Project	<b>IEEE 802.16 Broadband Wireless Access Working Group</b> < <a href="http://ieee802.org/16">http://ieee802.org/16</a> >	
Title	Supplementary Changes for Comment #30 in 80216-04/20	
Date Submitted	<b>2004-04-29</b>	
Source(s)	Lei Wang Wi-LAN Inc. 2891 Sunridge Way, NE Calgary, AB, Canada, T1Y 7K7	Voice: (403)273-9133 Fax: (403)273-5100  <a href="mailto:LeiW@wi-lan.com">Email: LeiW@wi-lan.com</a>
Re:	This is a contribution to IEEE 802.16-REVd.	
Abstract	This contribution describes the proposed changes to not have multiple UL channels for a DL channel in 802.16REVd.	
Purpose	To remove the unnecessary complexity in 802.16 systems.	
Notice	This document has been prepared to assist IEEE 802.16. It is offered as a basis for discussion and is not binding on the contributing individual(s) or organization(s). The material in this document is subject to change in form and content after further study. The contributor(s) reserve(s) the right to add, amend or withdraw material contained herein.

# Supplementary Changes for Comment #30 in 80216-04\_20

This document describes the supplementary changes for comment #30 in 80216-04\_20.

Figure 56—Obtaining uplink parameters

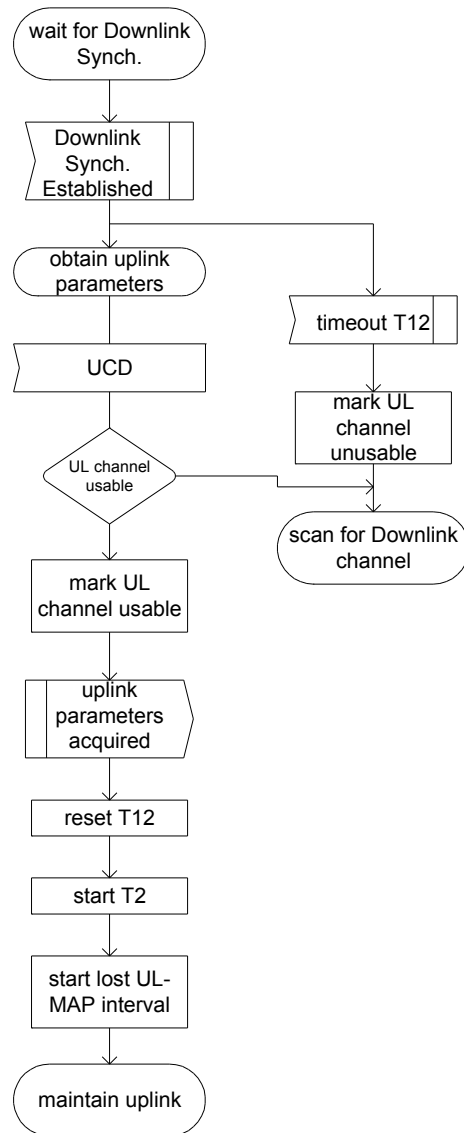
~~The SS shall collect all UCDs which are different in their channel ID field to build a set of usable channel IDs.~~ If no uplink channel can be found after a suitable timeout period, then the SS shall continue scanning to find another downlink channel. The process of obtaining uplink parameters is illustrated in Figure 56.

The SS shall determine from the channel description parameters whether it may use the uplink channel. If the channel is not suitable, then the SS ~~shall try the next channel ID until it finds a usable channel~~ continue scanning to find another downlink channel. If the channel is suitable, the SS shall extract the parameters for this uplink from the UCD. It then shall wait for the next DL-MAP message and extract the time synchronization from this message. The SS then shall wait for a bandwidth allocation map for the selected channel. It may begin transmitting uplink in accordance with the MAC operation and the bandwidth allocation mechanism.

The SS shall perform initial ranging at least once, per Figures 58 and 59. If initial ranging is not successful, ~~then the next channel ID is selected, and~~ the procedure restarted from UCD extraction scanning to find another downlink channel. ~~When there are no more channel IDs to try, then the SS shall continue scanning to find another downlink channel.~~ The SS MAC is considered to have valid uplink parameters as long as it continues to successfully receive the UL-MAP and UCD messages. If at least one of these messages is not received within the time intervals specified in Table 295, the SS shall not use the uplink. This is illustrated in Figure 57.
